REPORT AMENDED BY STAFF 3-23-89
CITY PLANNING COMMISSION

- APPLICATION:**
- A. Negative Declaration
 - B. Plan Review to develop a 44,110 sq. ft. retail/showroom and office/warehouse on 3.94+ vacant ac. in the Light Industrial-Review (M-1(S))-R zone
 - C. Lot Line Adjustment to merge 3 lots into one on 3.94+ vacant ac. in the M-1(S)-R zone

APPLC. NO. P89-085 MEETING DATE March 23, 1989 ITEM NO. 26

RALEY & BELL PROJECT

EXHIBIT A
SITE PLAN

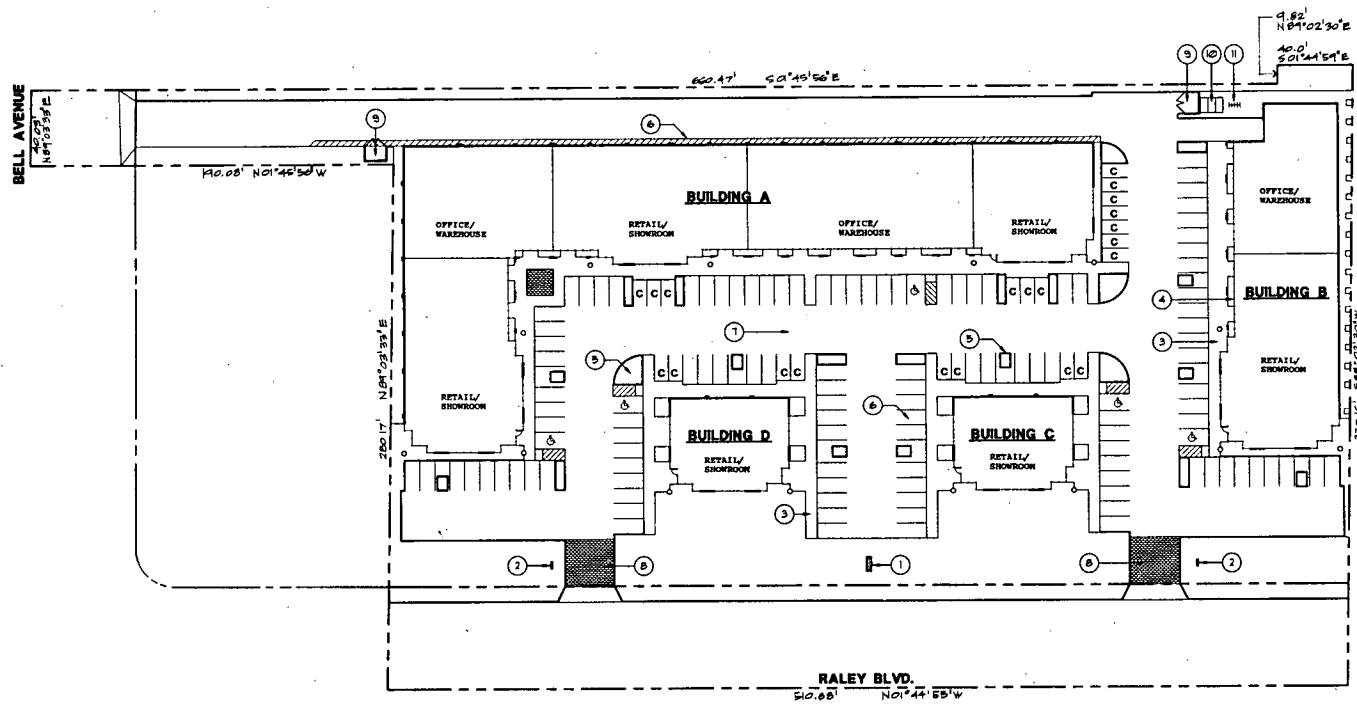
The submitted site plan indicates two entrances off of Raley Boulevard. Four individual buildings are proposed on the site. Staff felt that restaurant uses on the subject site would generate more traffic than any other retail type use. Parking spaces required for restaurant type uses are based on the number of seats proposed in the building (1:3). At this location parking spaces are calculated for retail square footage only and not seating capacity. All proposed restaurants on the site shall be reviewed and approved by the Planning Director prior to issuance of an occupancy permit. In addition, the subject site shall not exceed the total square footage indicated for retail space. The Building Division shall not issue any permits for tenant improvements for retail square footage that will cause an excess of 28,246 sq. ft., thereby creating a parking deficiency.

The site plan indicates a 50 ft. building setback along Raley Boulevard. A landscape plan has been submitted. The landscape plan indicates a 25' and 50' landscape setback with 3' architectural berms and 15 and 5 gallon trees are proposed along the side yard and front yard property lines between the buildings. Lawn material is also shown on the site plan. The applicant shall provide 3-1/2' undulating berms with 15 gallon trees and 5 gallon shrubs along Raley Boulevard. The landscape and irrigation plans shall be submitted to the planning Director for review and approval prior to issuance of building permits. The subject site shall be required to meet the Zoning Ordinance 50% shading requirement.

Two trash enclosures are indicated on the site plan. The proposed enclosures shall conform with the City's Trash Enclosure Ordinance. Three bicycle lockers and five bicycle racks are shown on the site plan.

As previously noted, there are two driveway entrances off of Raley Boulevard. The site plan indicates 112 standard size parking spaces, 21 compact spaces and 4 handicapped spaces (total 137). One-hundred and thirty-five (135) spaces are required for the subject site based on the square footage of each type of use. The applicant has met the parking required for the site.

The Building Division has indicated that a minimum 3" concrete base shall be provided underneath the concrete paves shown on the site plan. In addition, an 8' walkway with no wheel stops shall be provided between the building and the parking spaces.

2. ~~The proposed building square footage indicated for retail space shall not exceed the total square footage indicated for retail space on the submitted site plan. The Building division shall not issue any permits for tenant improvements for retail square footage that will cause an excess of 28,246 sq. ft., thereby creating a parking deficiency.~~
The proposed building square footage indicated for retail space shall not exceed 28,246 sq. ft., unless prior to issuance of a building permit the applicant submits a revised site plan demonstrating to the Planning Director that adequate parking is available. (staff amended)

3. The applicant shall provide 3-1/2' undulating berms with 15 gallon trees and 5 gallon shrubs along Raley Boulevard.
4. Final landscape and irrigation plans shall be submitted to the Planning Director for review and approval prior to issuance of building permits.

5. The subject site shall be required to meet the Zoning Ordinance 50% shading requirement.

6. Trash enclosures shall conform with the City's Trash Enclosure Ordinance.
7. A minimum 3" concrete base shall be provided underneath the concrete paves.
8. An 8' walkway with no wheel stops shall be provided between the building and parking spaces.
9. The applicant shall submit a sign program for the proposed complex for review and approval by the Planning Director prior to issuance of a sign permit.
10. The right-of-way along Raley Boulevard shall be dedicated to a 55' half-section and Bell avenue to a 40' half-section.
11. The applicant shall obtain driveway permits prior to issuance of building permits.
12. The applicant shall join either the Bell Avenue Assessment District or Fee District to utilize sewer, drainage and water in the public right-of-way

**EXHIBIT C
ELEVATIONS**

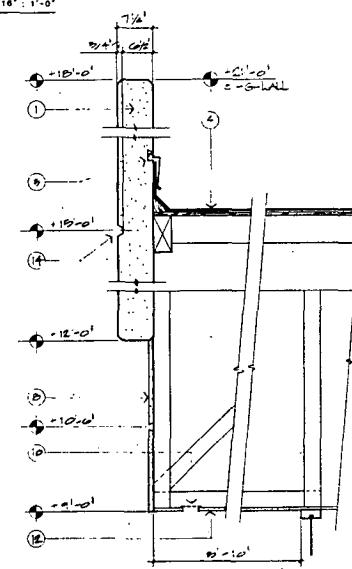
The site plan indicates a total of four buildings on the site (see Exhibit A). The proposed building material will consist of painted concrete tilt-up walls. Roofing material will consist of 4-ply built up roof. The buildings will provide canvas awnings. A painted accent border will also be provided on the buildings. The Design Review Coordinator has indicated that the building's elevations are acceptable.
